PROJECT TITLE
Owens Park, Fallowfield;
Campus Redevelopment

DRAWING TITLE
East and South Facing Elevations - Building 107

Exterior Material Amendments Schedule

This schedule issue sets out amendments to items 9, 10 and 11 and acts to supersede the relevant parts of the BDP document (SCH)_A034_Exterior Material Schedule.

DRAWING TITLE
Internal Elevations - Building 108

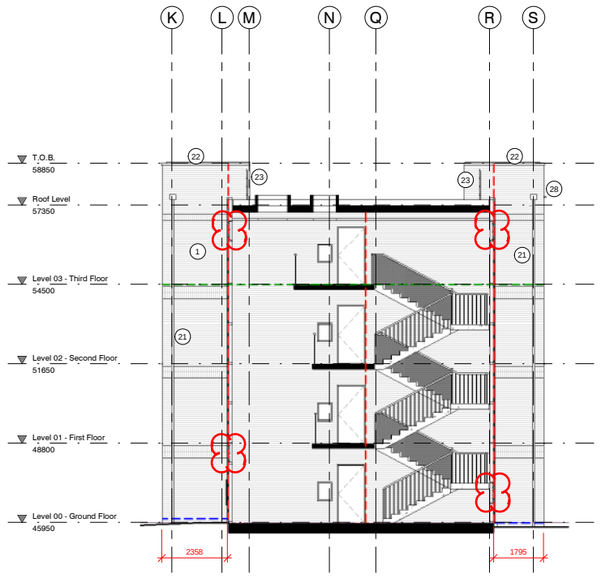
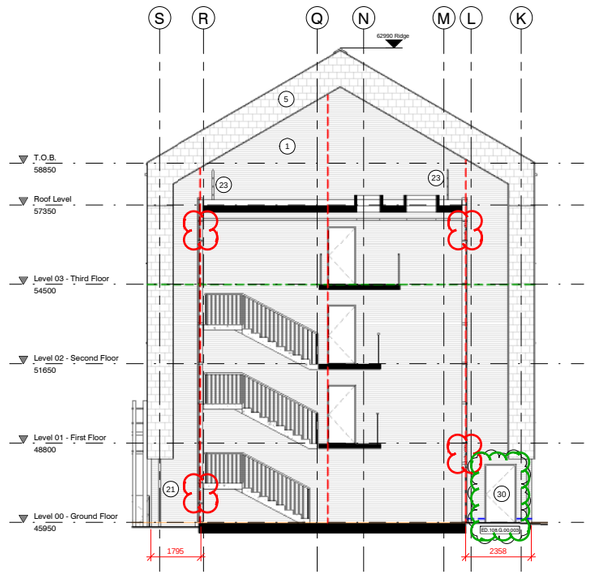
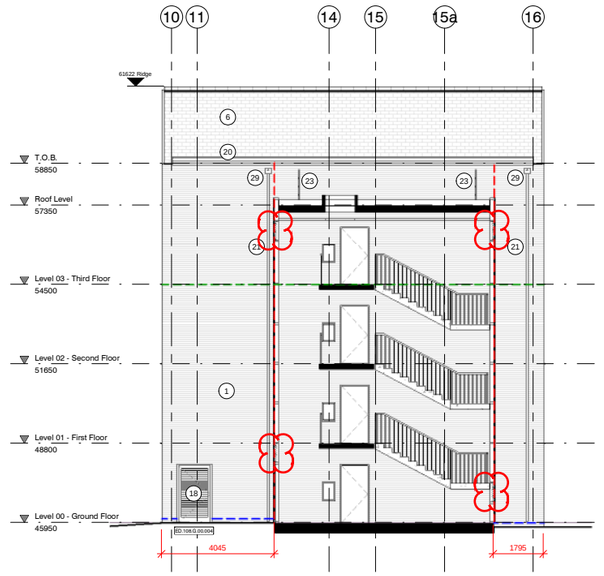
GLASS LOUVRES AMENDED TO BE PPC METAL

DOOR IN GREEN AMENDED TO BE SOLID METAL LOUVRES REMOVED

DRAWING TITLE
Energy Centre Building 51
Elevations for planning amendment application

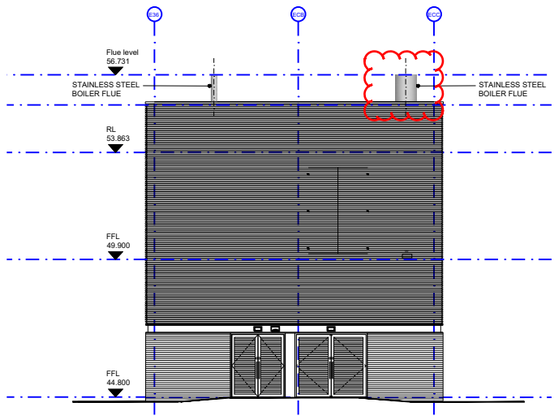
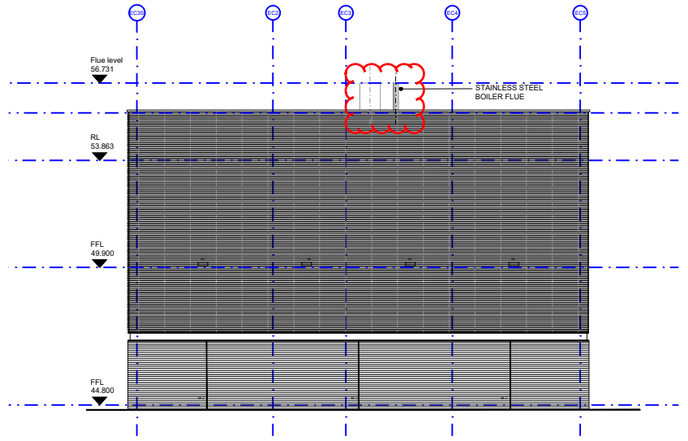
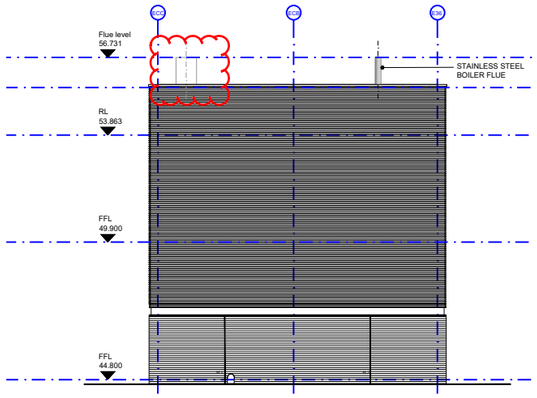
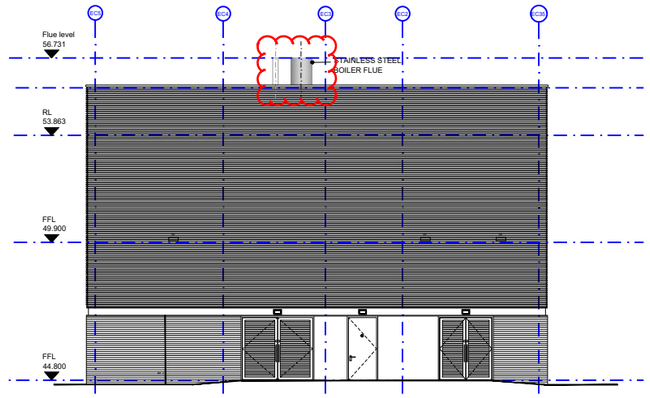
FLUE POSITION AMENDED DUE TO M&E DESIGN
